## Addendum No. 4

Project: DSU Living and Learning Commons Laundry Room Renovation

Project number: FD-14-037.04

# TRAP GUARD FLOOR DRAIN

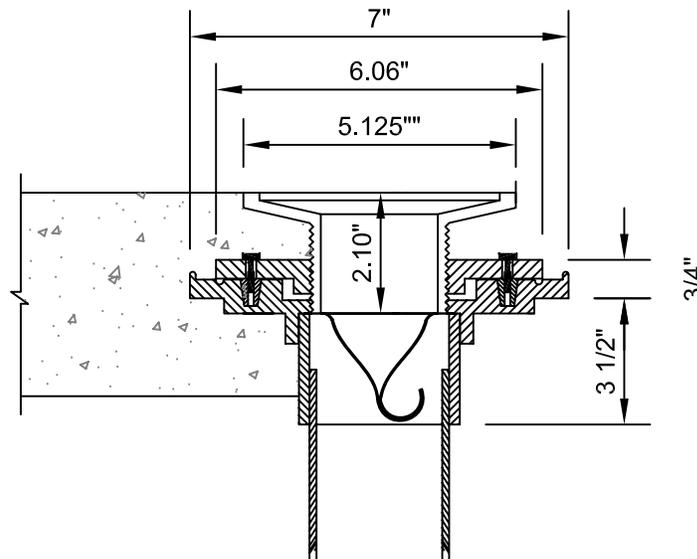
3. **Question:** Trap Primers are not shown for the floor drains. They will be required?  
**Answer:** In lieu of trap primers, provide each floor drain with an integral trap guard. See attached cut sheet herein, which shall serve as the basis of design for all floor drains.

1. In lieu of trap primers, provide each floor drain with an integral trap guard. See attached which shall serve as the basis of design for all floor drains. Refer to drawings for sizes.
2. "Gypsum board soffit" indicated in the documents shall be constructed from 2 ½" CFMF studs @16" O.C. with 5/8" GWB – Type X, finished per specifications.
